| PRELIMINARY Basis of Design Report <input type="checkbox"/> ACCEPTED <input checked="" type="checkbox"/> ACCEPTED AS NOTED <input type="checkbox"/> REVISE AND RESUBMIT | 9379 E San Salvador Dr. Scottsdale, AZ 85258 |

**WASTEWATER COLLECTION SYSTEM
PRELIMINARY BASIS OF DESIGN REPORT
FOR
ASM SCOTTSDALE**

August 30, 2024
WP# 235526

3-DR-2024

SCALE (HORIZ.) #####
SCALE (VERT.) 1" = 4'
DATE 08/30/2024
JOB NUMBER 235526
SHEET C36 OF 43

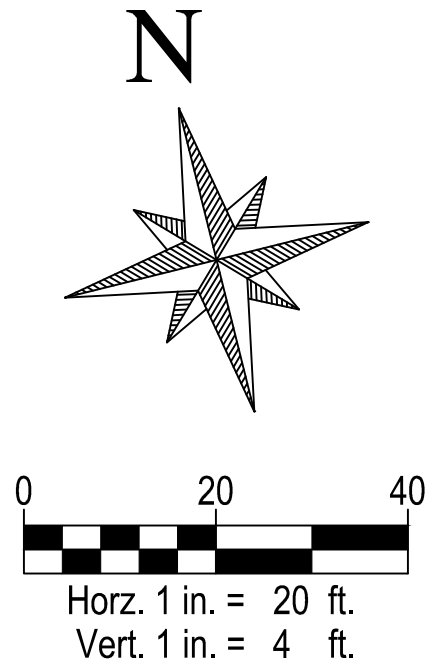
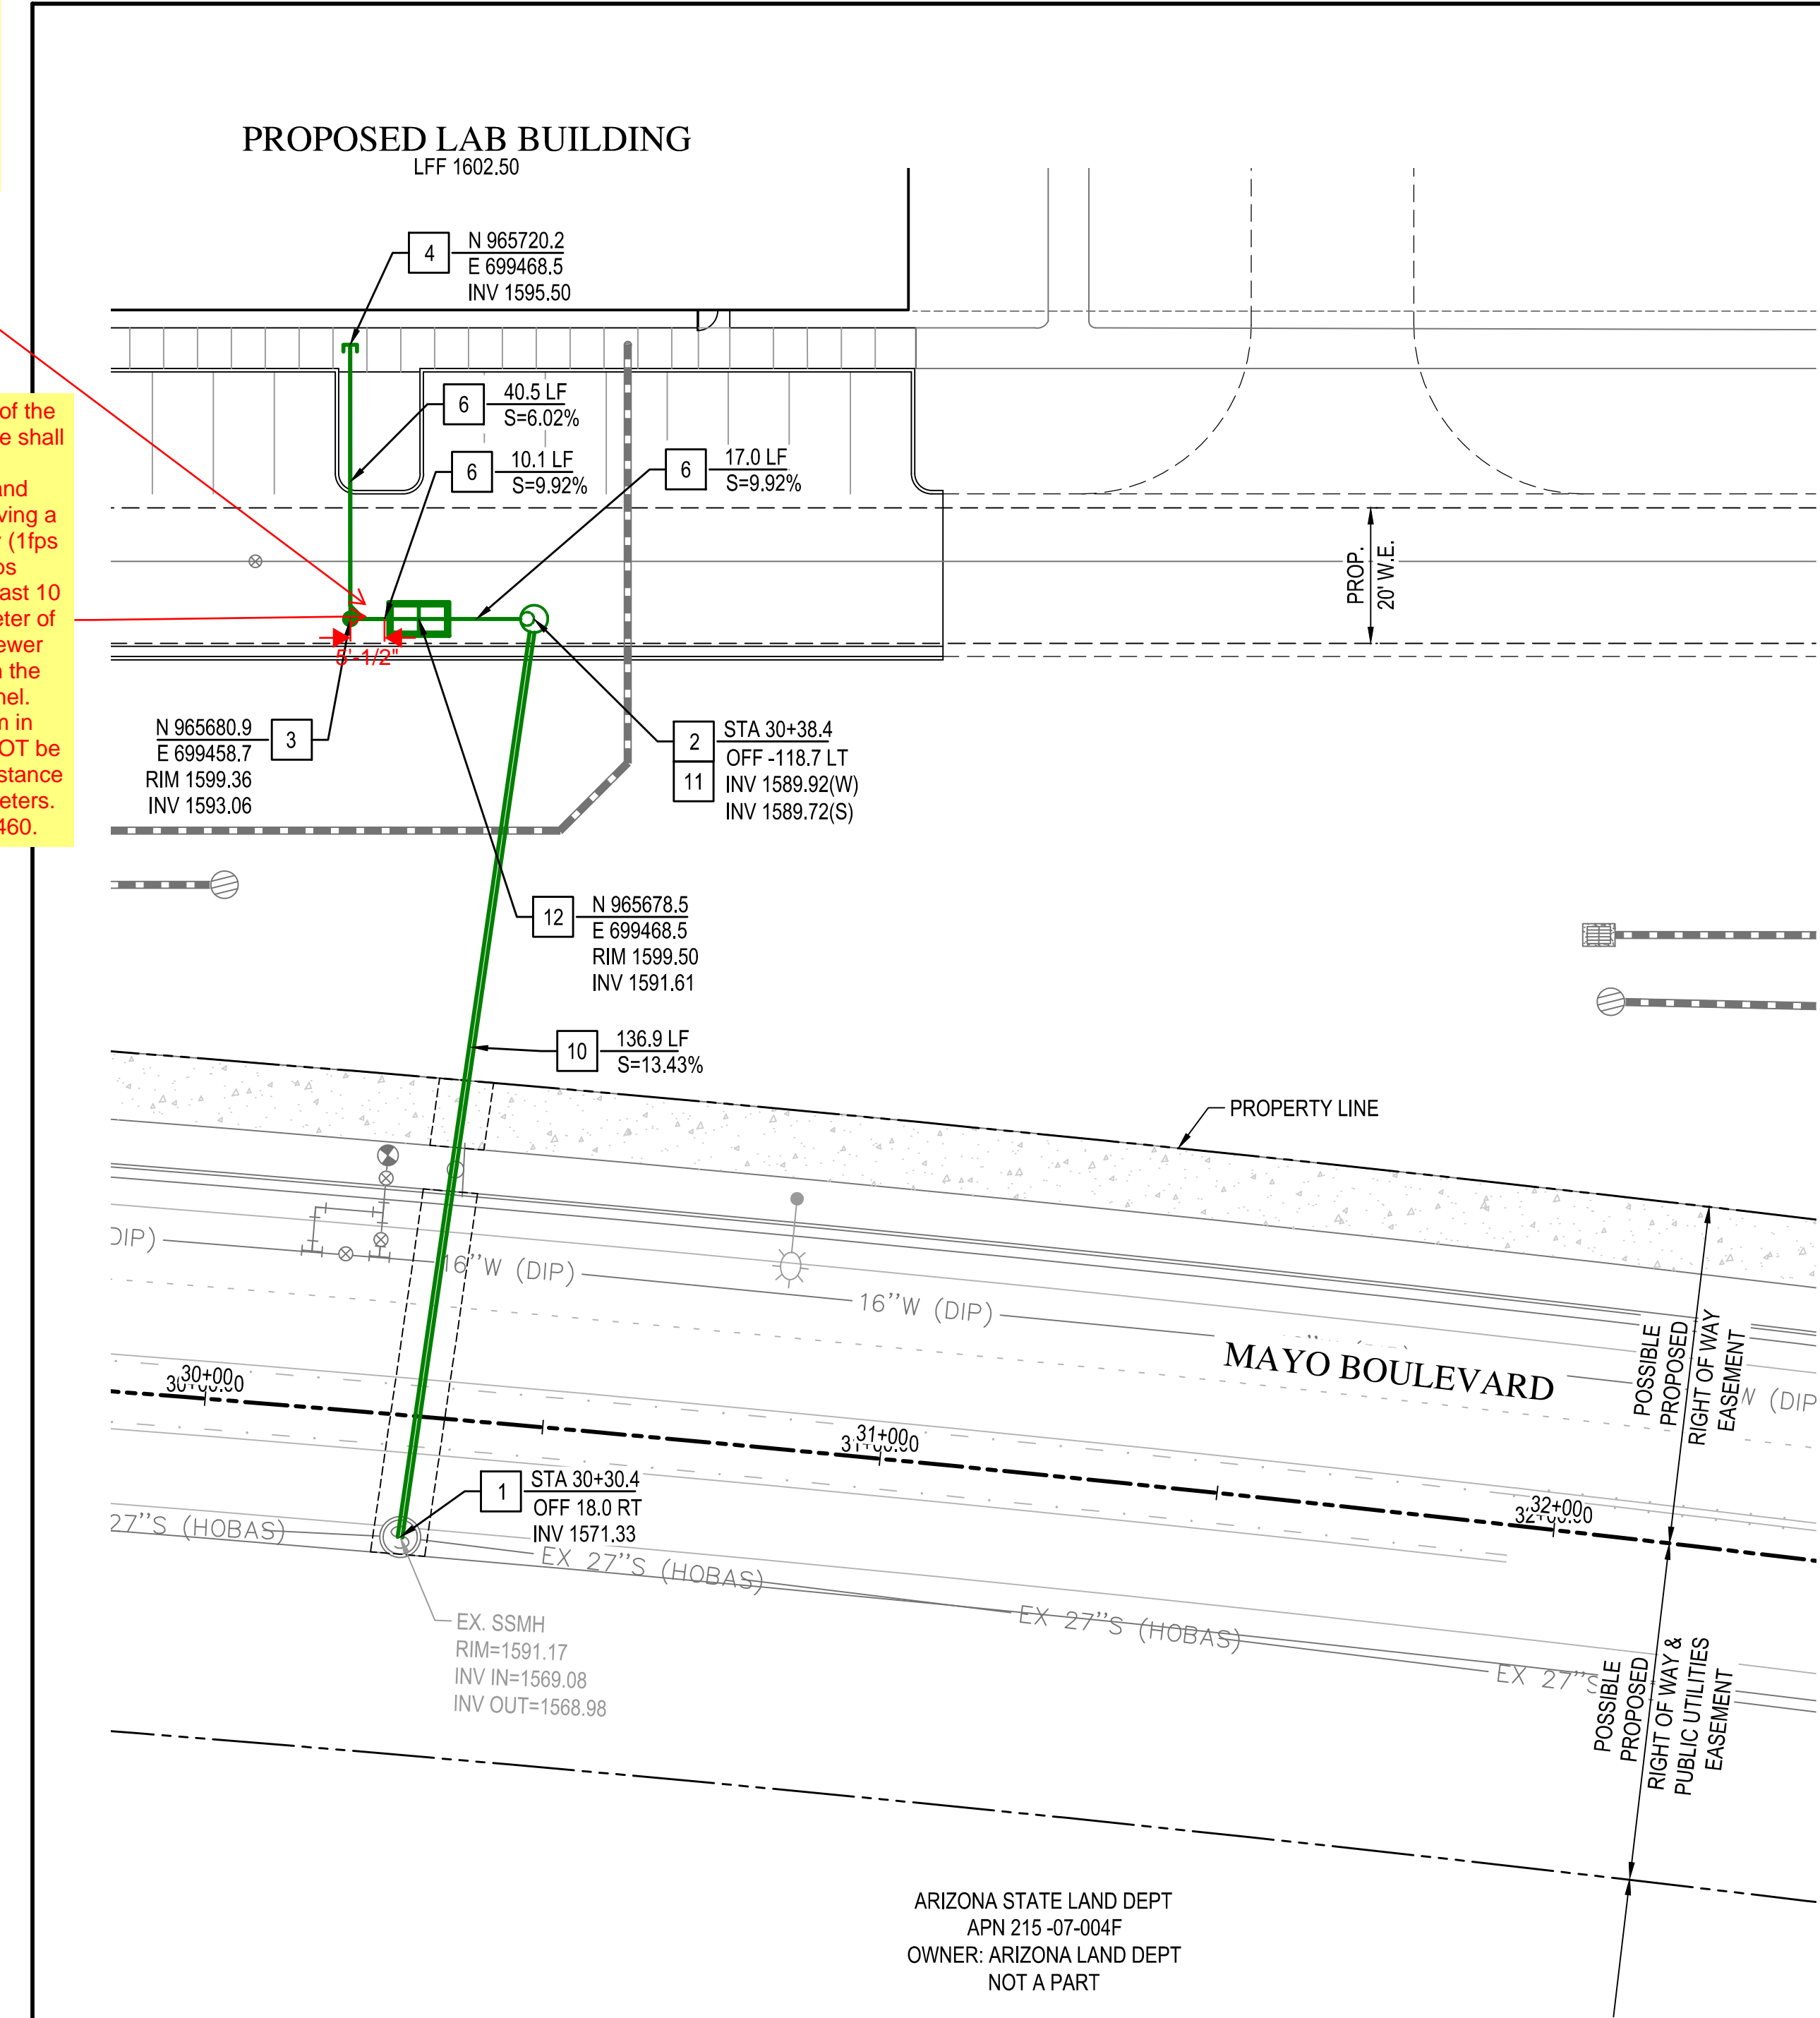
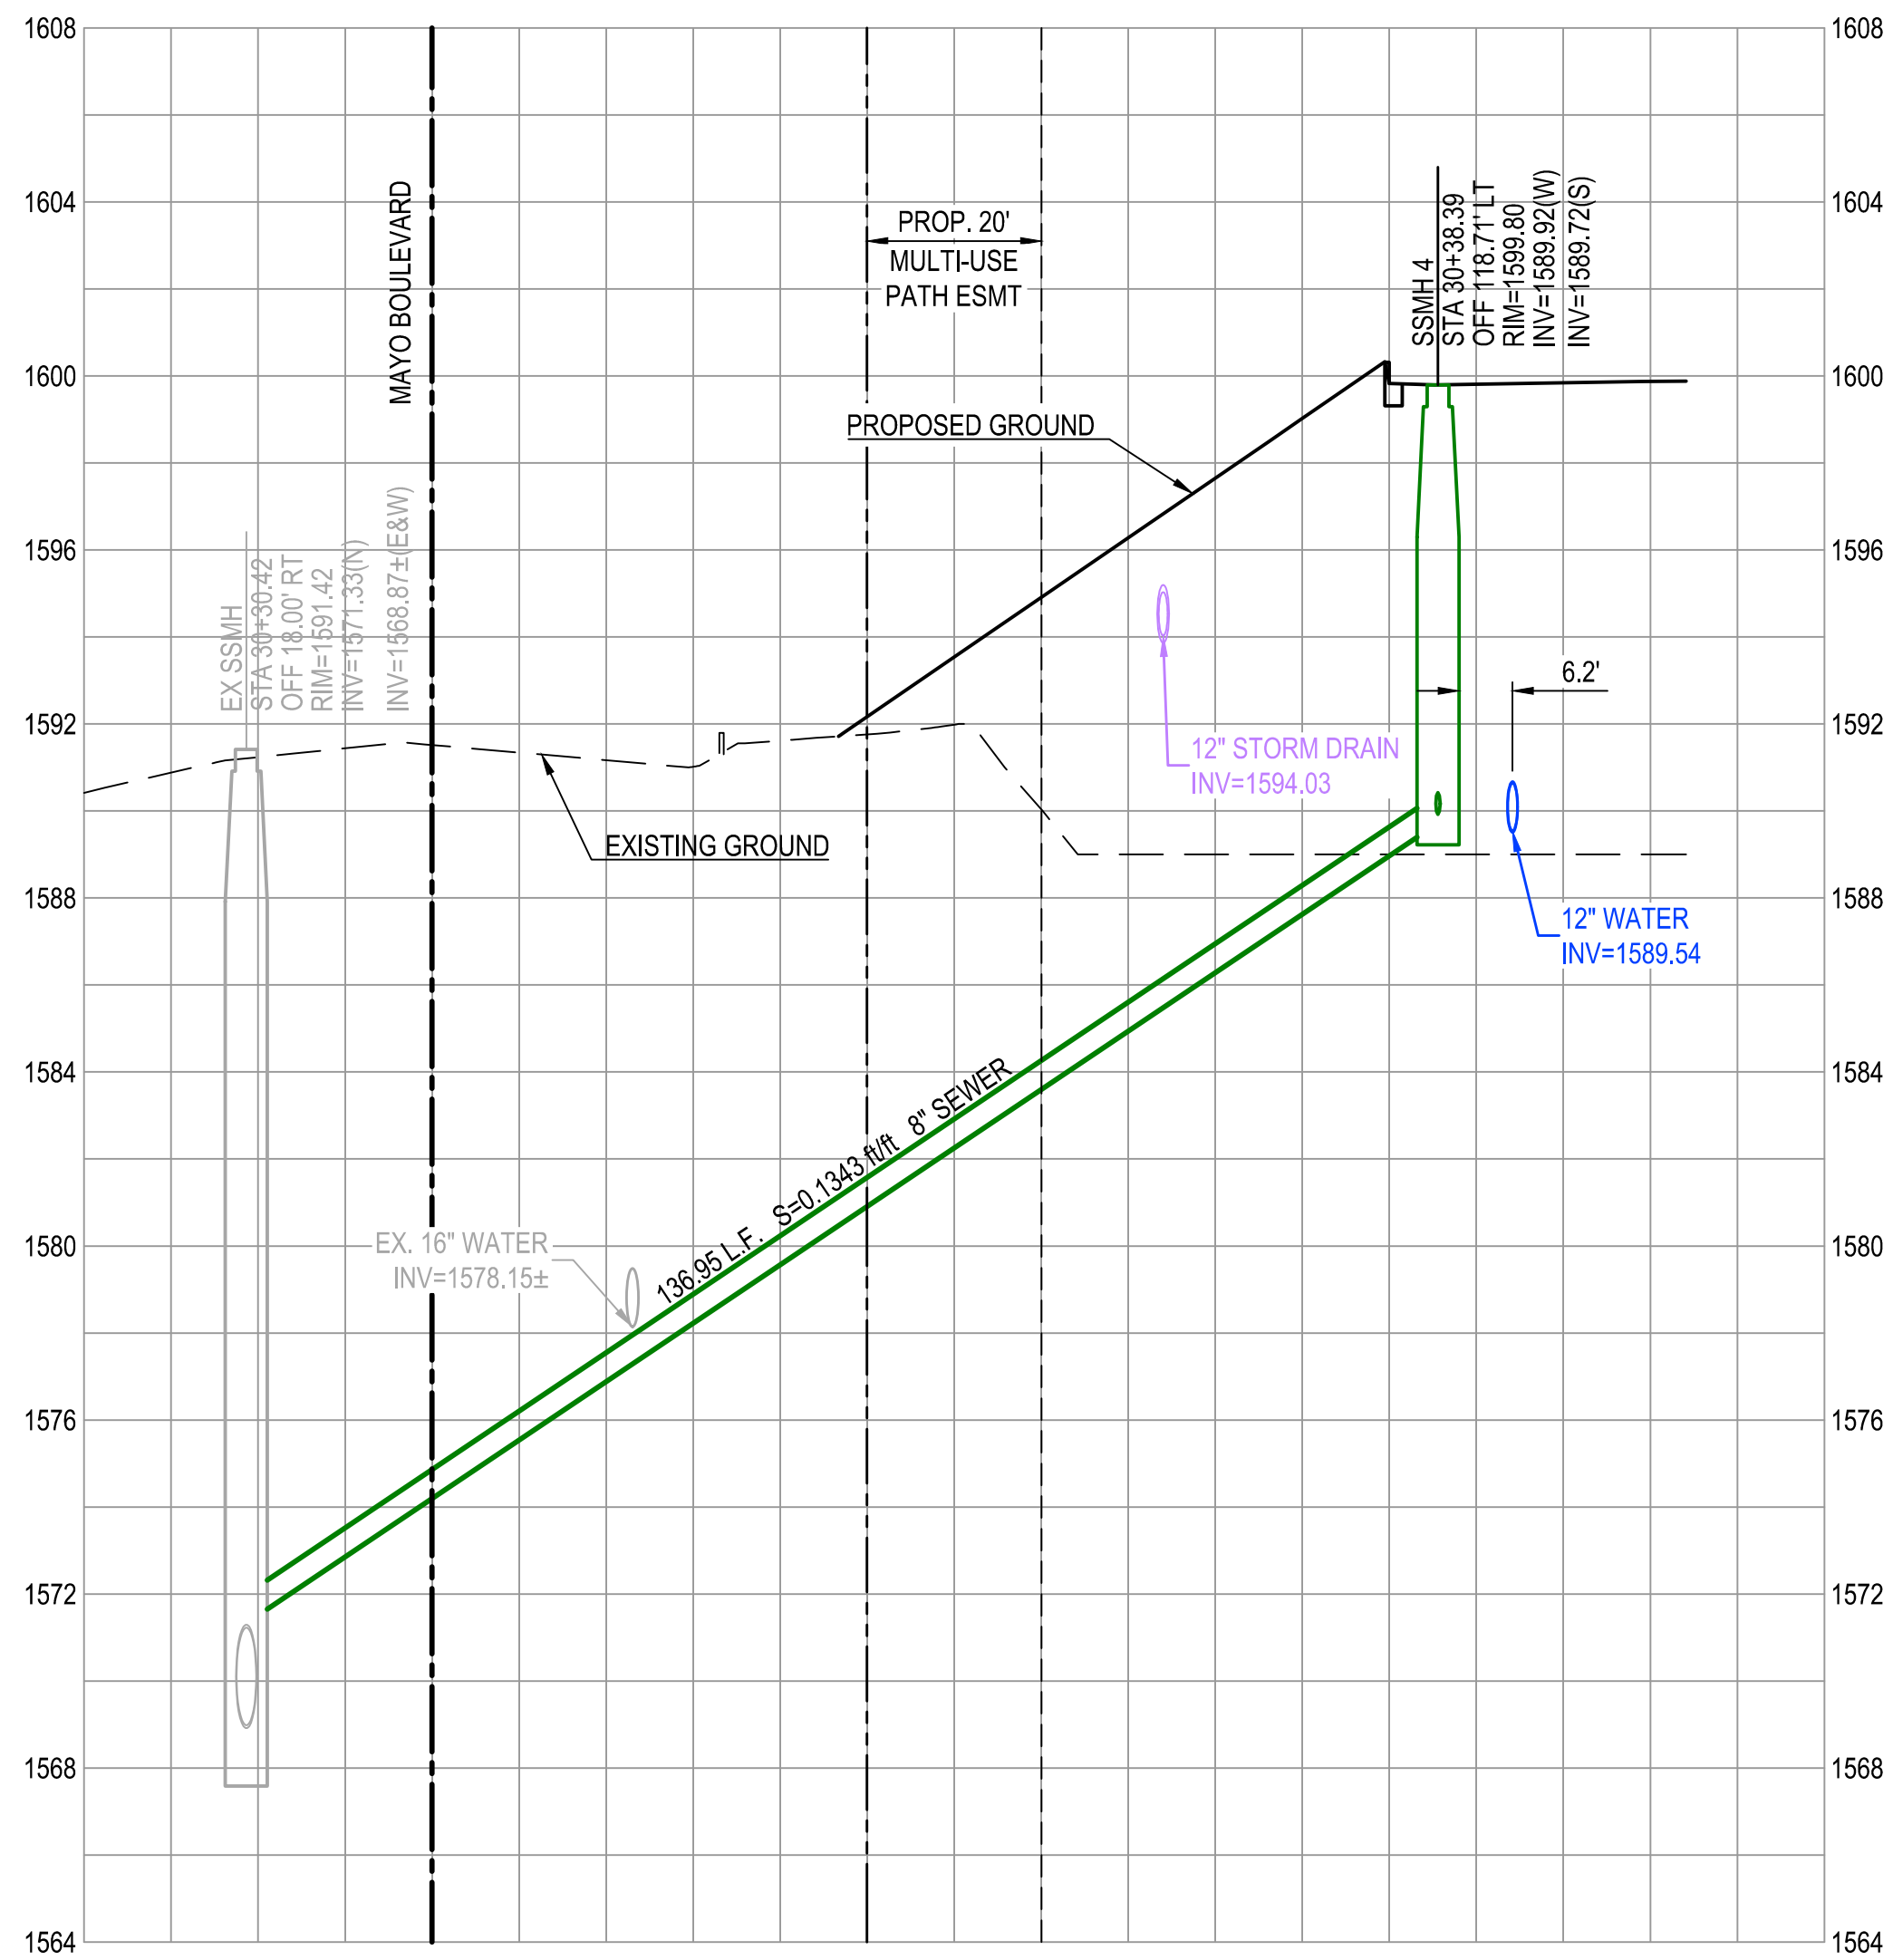
At a slope of 0.0992 ft/ft and 261 gpm peak flow (Table 3 of BOD), the velocity exceeds the 3 ft/s maximum velocity required upstream of the monitoring flume. COS Std. Det 2460.

Flow upstream of the monitoring flume shall be wave free, non-turbulent, and symmetrical having a uniform velocity (1fps minimum to 3 fps maximum) at least 10 times the diameter of the upstream sewer pipe in length in the approach channel. Bends upstream in the flume will NOT be allowed for a distance of 25 pipe diameters. COS Std Det 2460.
